City of Richmond

Re: Application by – Cotter Architects for Development Permit at
14000 Riverport Way

File: DP 11-593925

Re: **Application by Cotter Architects for a Development Permit at
14000 Riverport Way**

SECTION 3-3
SCALE 1:100

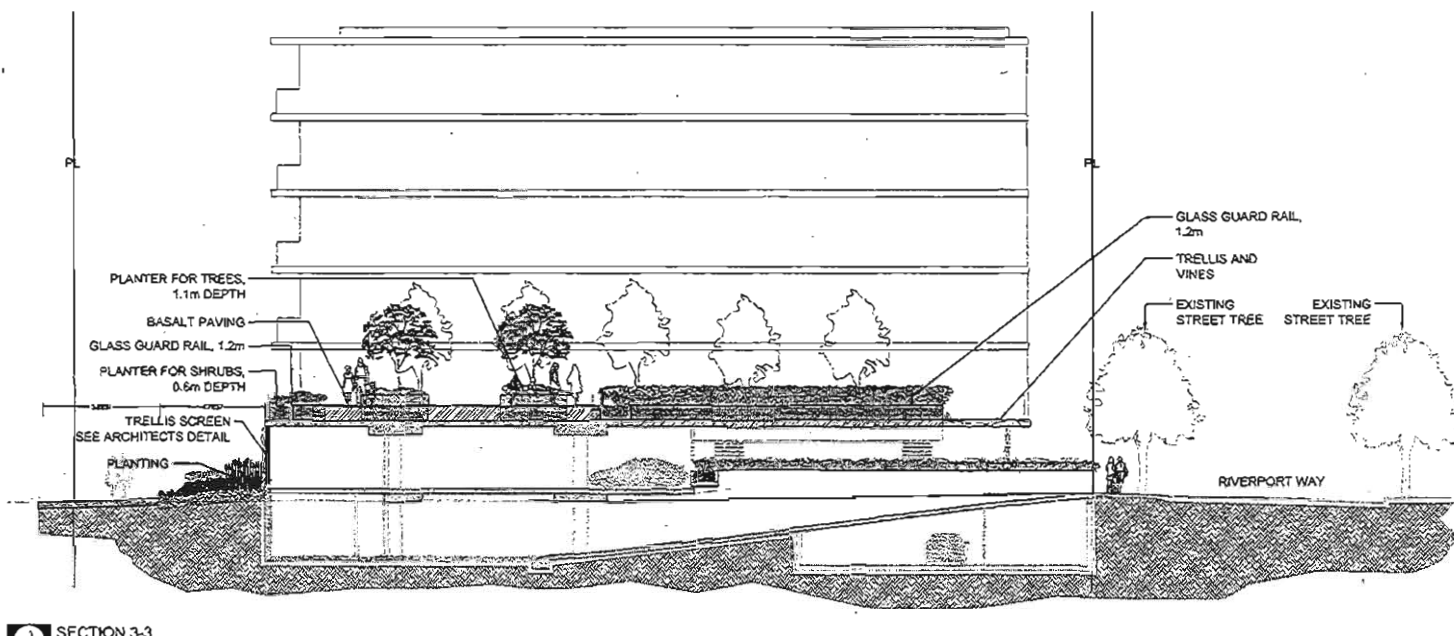
- berm transition at the back of parkade to the dyke is a bit clumsy as shown in section on L-05; context in the drawing on both sides would have been more helpful – ***Improved with additional planting and architectural trellis with vine planting. Context included.***
